**Transport**  
Roads & Maritime  
Services

# **FAUNA CONNECTIVITY REPORT (TABLE 6.2)**

## **Oxley Highway to Kundabung**

**DECEMBER 2014**

# Culvert CH 11660

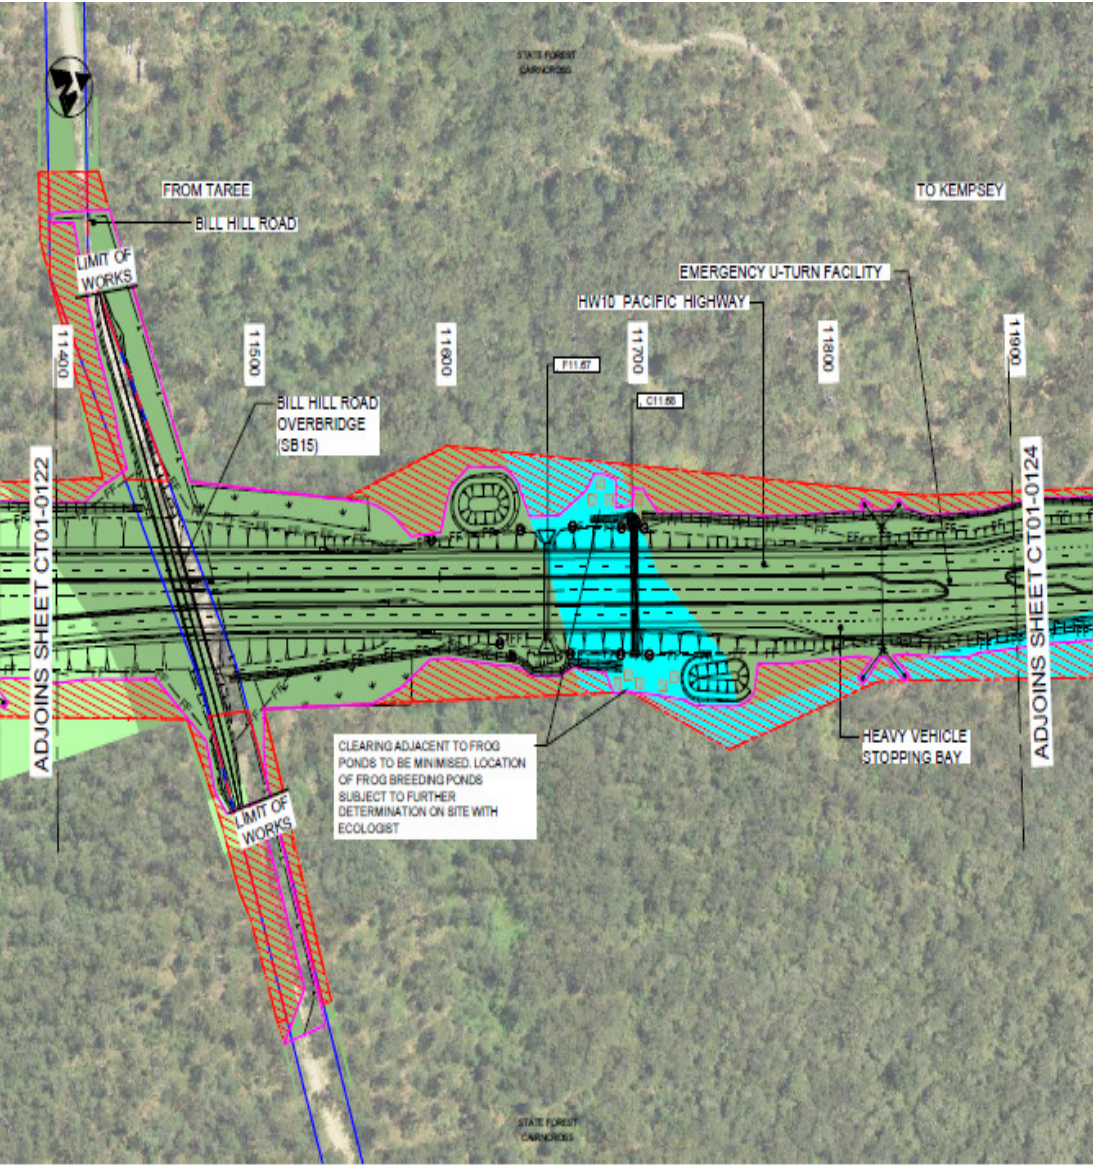
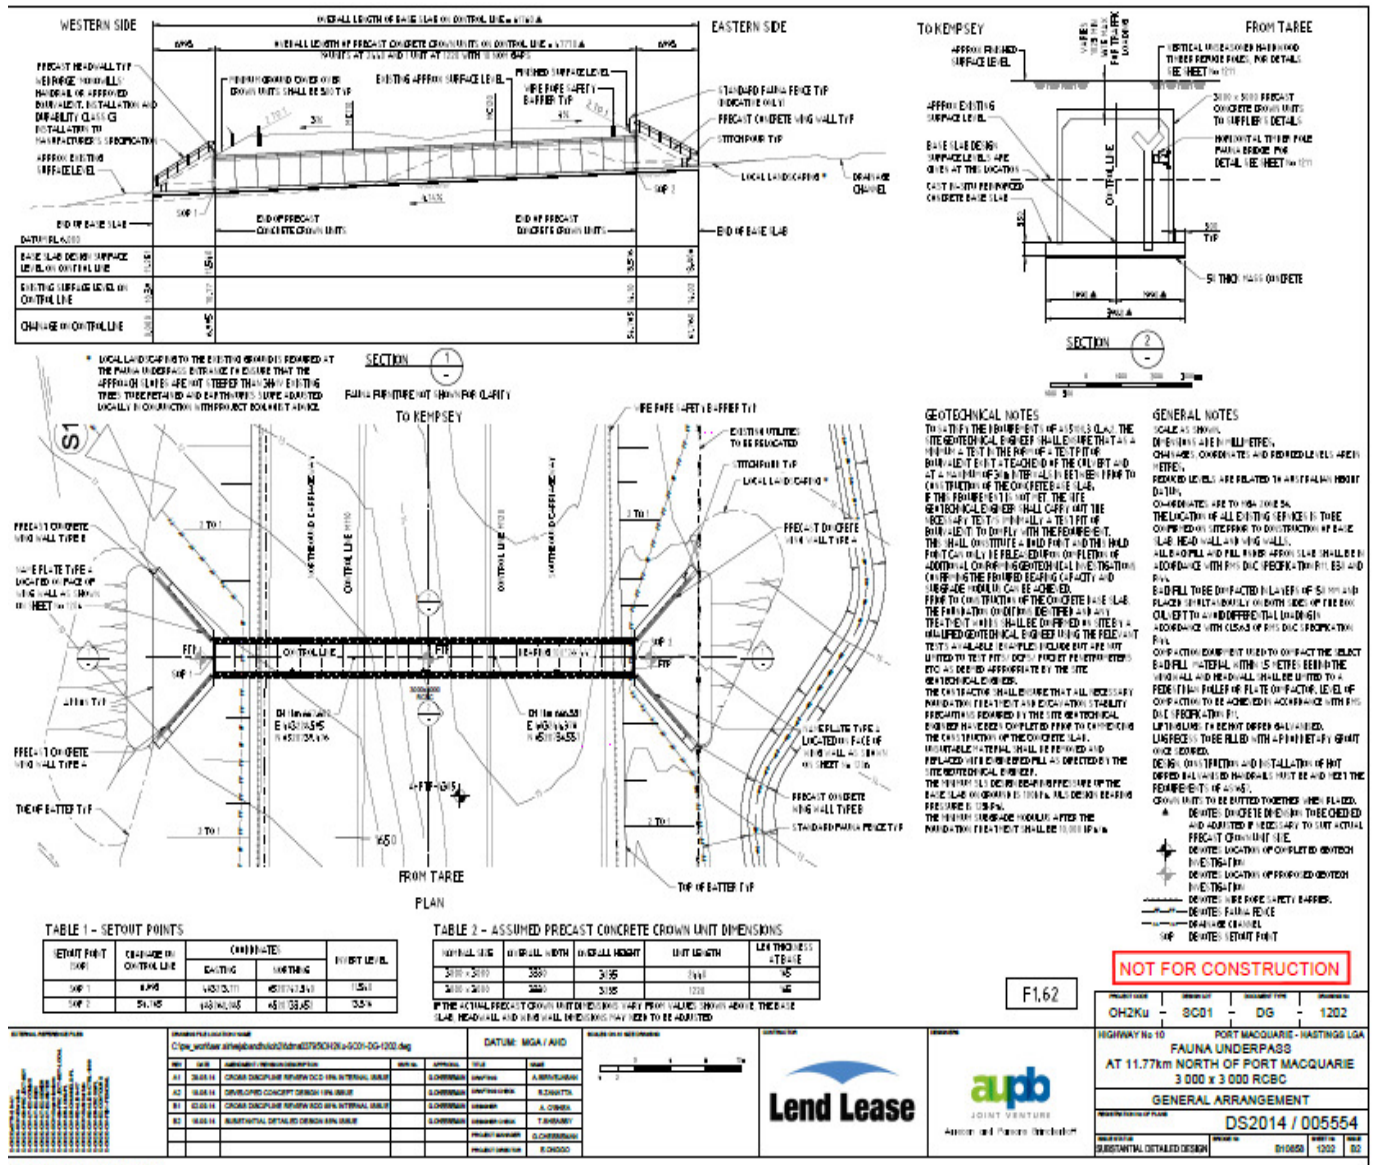
F11.67	Dedicated	11670	1 cell 3.0 x 2.4 RCBC	Overall length 41.0m	Dedicated	11660	no change proposed	Overall length 38.0m	No	Install rail and refuge poles (every ~15m) (koalas); install refuge poles at entry and exit to culvert rocks & logs (frogs/reptiles/sm. mammals) within culvert; hollow logs outside near entry/exit (quolls)	Located within mapped regional corridor, links vegetation in Cairncross State Forest to the east and west	Positive	Positive
SB09	Twin bridges-Wilsons River	16400-17000	-	Overall length: 523	Twin bridges-Wilsons River	16400-17000	-	no change proposed	N/A	N/A	-	N/A	N/A
SB10	Twin bridges-North Coast Railway Line	17200-17300	-	Overall Length: 25	Twin bridges-North Coast Railway Line	17200-17300	-	no change proposed	N/A	N/A	-	N/A	N/A
C17.70	Combined	17700	1 cell 3.0 x 3.0 RCBC	Overall length 56.0m	Combined	17690	no change proposed	Overall length 40.4m	upstream 10% 6m downstream 1% 10m (shallow regarde just need to tie into ground level to make culvert drain freely)	Install refuge poles at entrance and exit; Install rail throughout culvert; Install concrete (or equivalent) ledge (900mm(W) x 300mm(H)) along one wall to provide dry access.	Fragmented vegetation to the east and west	Positive	Neutral (Regraded culvert: Install concrete (or equivalent) ledge (900mm(W) x 300mm(H)) along one wall to provide dry access

<b>Location: F11.67</b>	
Crossing type:	Dedicated
SWTC Table 6.2 location(s)	CH 11670
SWTC Table 6.2 Structure form(s)	Box culvert
SWTC Table 6.2 dimensions(s)	1 Cell, 3m wide x 2.4m high
Original location vegetation	Swamp Mahogany Red Gum Swamp Forest
Watercourse	N/A
Connectivity value	Very high- in regional corridor
Proposed location	CH11660
Proposed structure	Unchanged
Proposed dimensions	Unchanged
New location vegetation	Swamp Mahogany Red Gum Swamp Forest
Reason for design change	The culvert has been relocated to provide dry passage above the 100 ARI flood level to meet both EPBC condition 3 requirements.
Engineering considerations:	Length of the culvert has been reduced through the relocation, now being 38m in length.
Ecological outcome:	Positive biodiversity outcome.

Culvert CH 17690

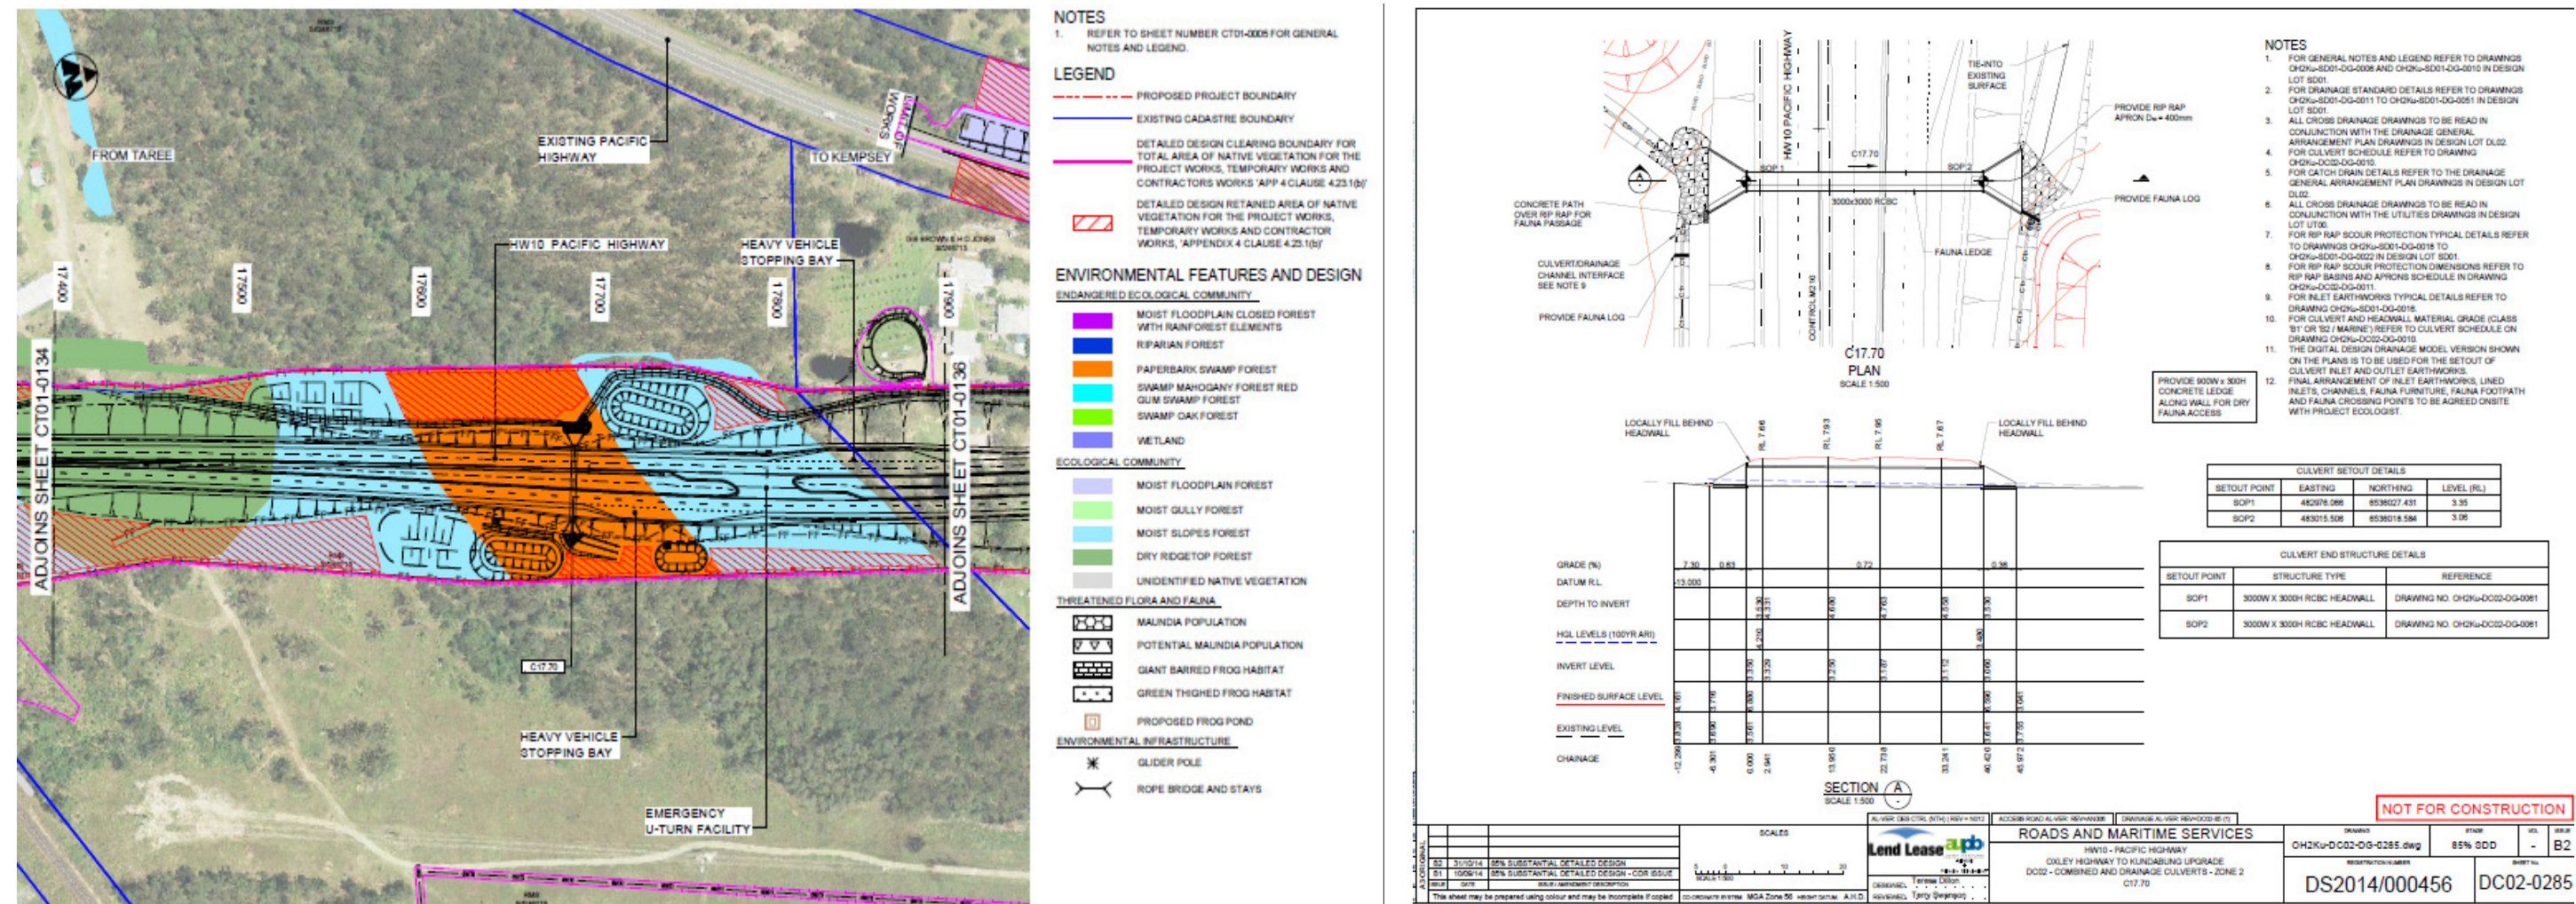
<b>Location: C17.70</b>	
Crossing type:	Combined
SWTC Table 6.2 location(s)	CH 17700
SWTC Table 6.2 Structure form(s)	Box culvert
SWTC Table 6.2 dimensions(s)	1 Cell, 3m wide x 3m high
Original location vegetation	Paperbark Swamp Forest
Watercourse	N/A
Connectivity value	N/A
Proposed location	CH11690
Proposed structure	Unchanged
Proposed dimensions	Unchanged
New location vegetation	Paperbark Swamp Forest
Reason for design change	Culvert has been straightened to reduce the length of the structure.
Engineering considerations:	The relocation of the culvert has resulted in a regrade required either side of the highway.
Ecological outcome:	Neutral biodiversity outcome.
Fauna exclusion fencing provisions	<p>Standard fauna fencing is located around the highway formation at this location. Fencing will be located over the top of the headwall of the crossing allowing this culvert to be used by fauna.</p> <p>Drop down structures will be provided in locations in close proximity to the underpass, as agreed with the project ecologist and confirmed onsite with OEH.</p>

51/C17.70	17700	Combined	<p>Changed from multi-use structure to combined structure.</p> <p>Decrease in length from 57.6 metres to 56 metres.</p> <p>Size decreased from 3.6 x 3.6m to 3 x 3m.</p>	<p>Larger size in Table 6-2 (RMS 2011) as was a multi-use crossing predominantly for property, livestock and vehicle access. Propose to change to combined crossing as vehicle/livestock passage no longer required. Size changed to 3m x 3m in line with other fauna culverts.</p> <p>Slight decrease in length due to reduced project</p>

Culvert CH 20560

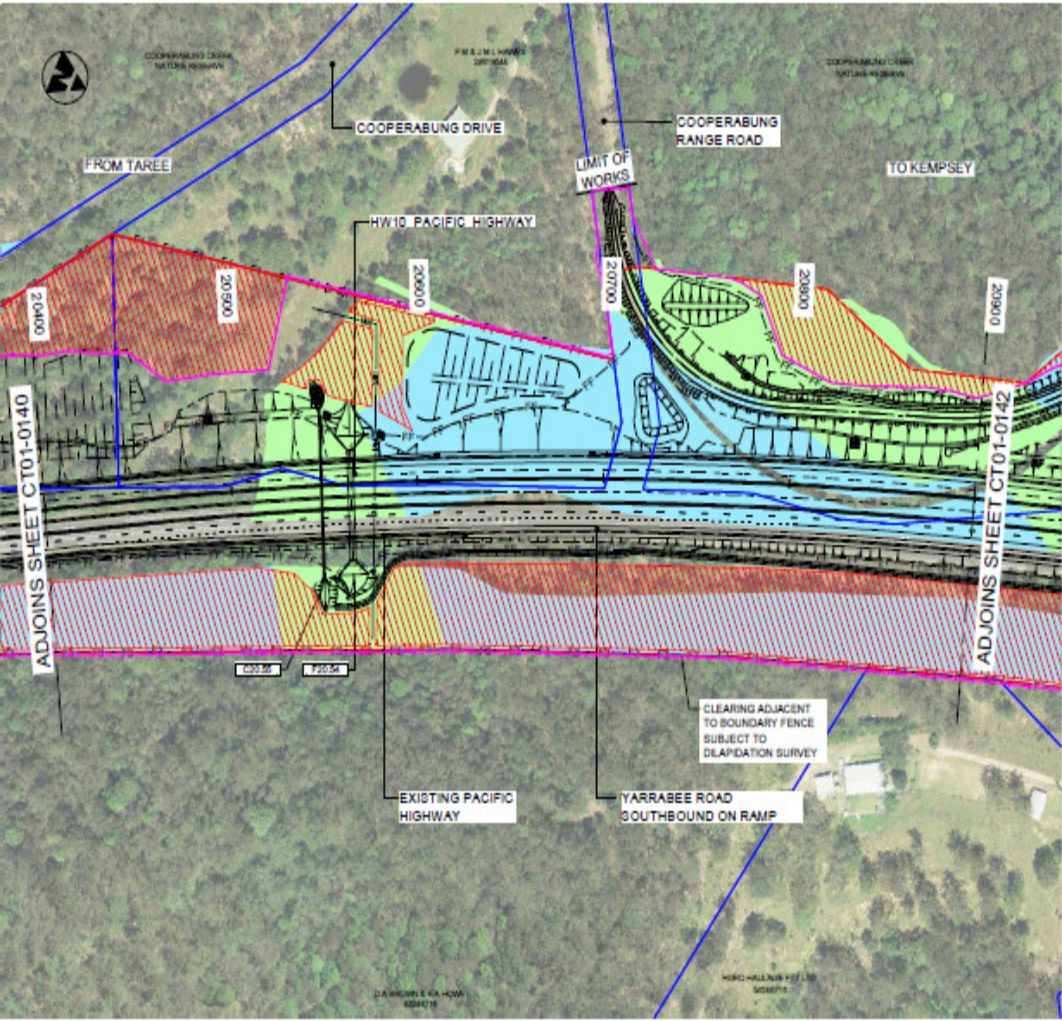
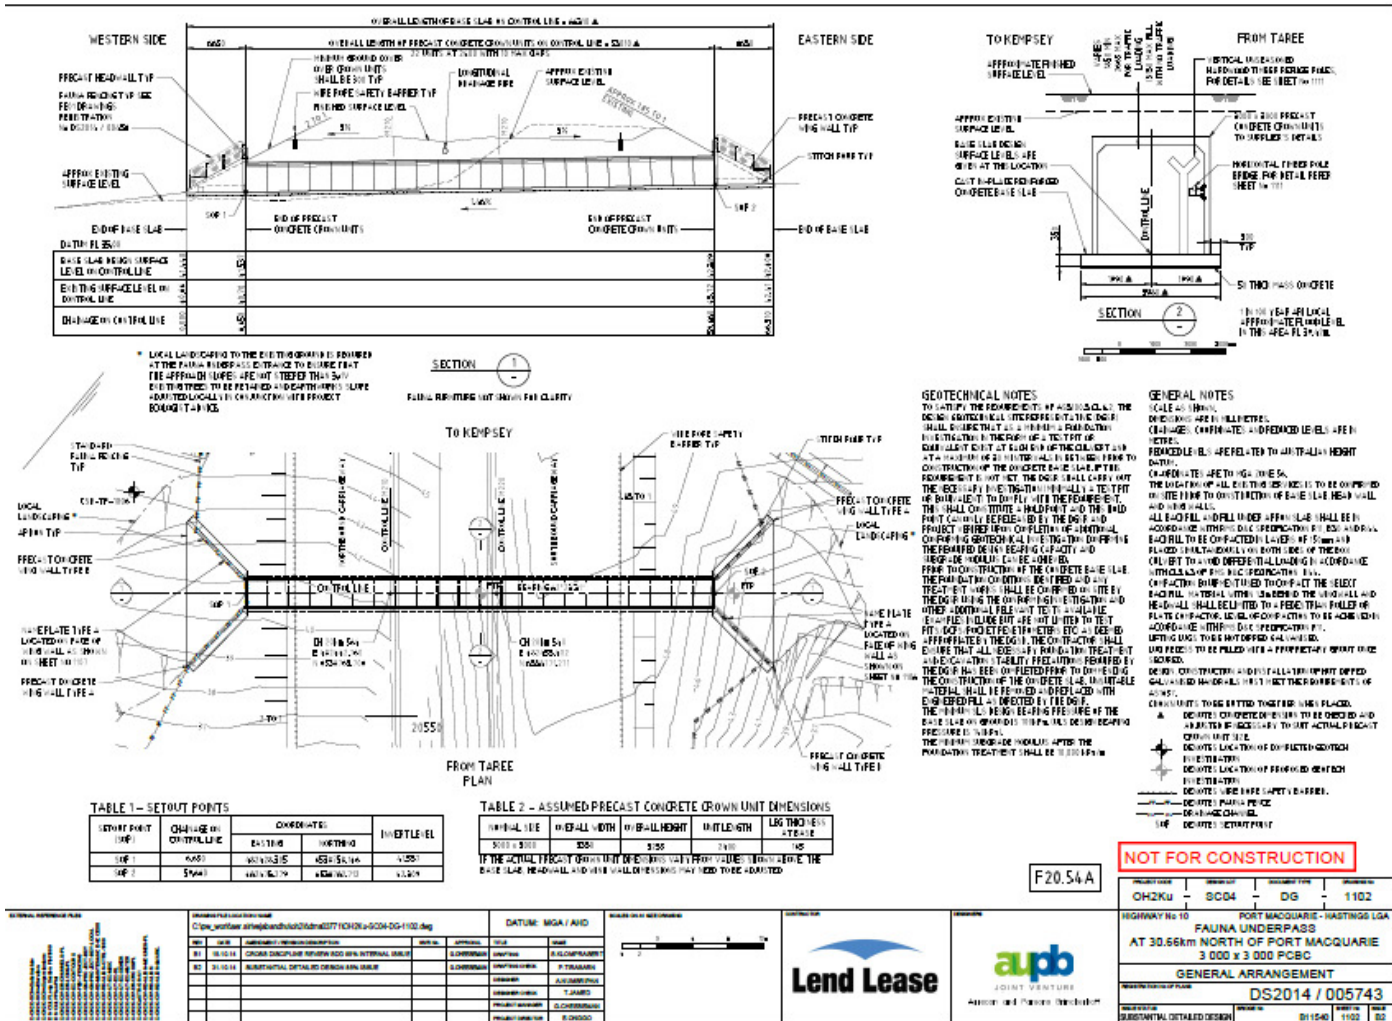
<b>Location: F20.54</b>	
Crossing type:	Dedicated
SWTC Table 6.2 location(s)	CH 20540
SWTC Table 6.2 Structure form(s)	Box culvert
SWTC Table 6.2 dimensions(s)	1 Cell, 3m wide x 3m high
Original location vegetation	Moist Gully Forest
Watercourse	N/A
Connectivity value	Very High- links vegetation that is contiguous with mapped regional corridor in Cooperabung Nature Reserve and Ballengarra State Forest.
Proposed location	CH20560
Proposed structure	Unchanged
Proposed dimensions	Unchanged
New location vegetation	Moist Gully Forest (NB)
Reason for design change	The culvert was shifted as the original location placed the culvert in a drainage line. By moving it 20m north, it removed the culvert from the low topography and enabled it to provide dry passage above the 100 ARI flood level to meet both EPBC condition 3 requirements.
Engineering considerations:	IN addition to the relocation, the culvert was placed higher in the fill embankment. Both of these changes have resulted in the substantial reduction in length to 53m.
